Product Change Notice (PCN)

Subject: Bond wire material change for RL78/F12, F13, F14 Series SSOP package products

Publication Date: 12/25/2024

■Marking specification

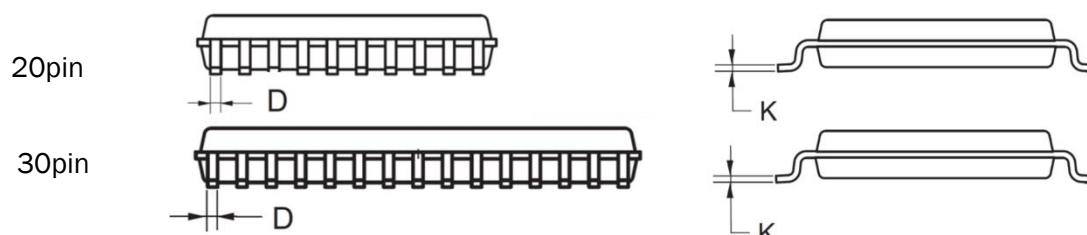
The first stage will be changed as follows.

Mark example

1st line Product name

2nd line: Trace Code
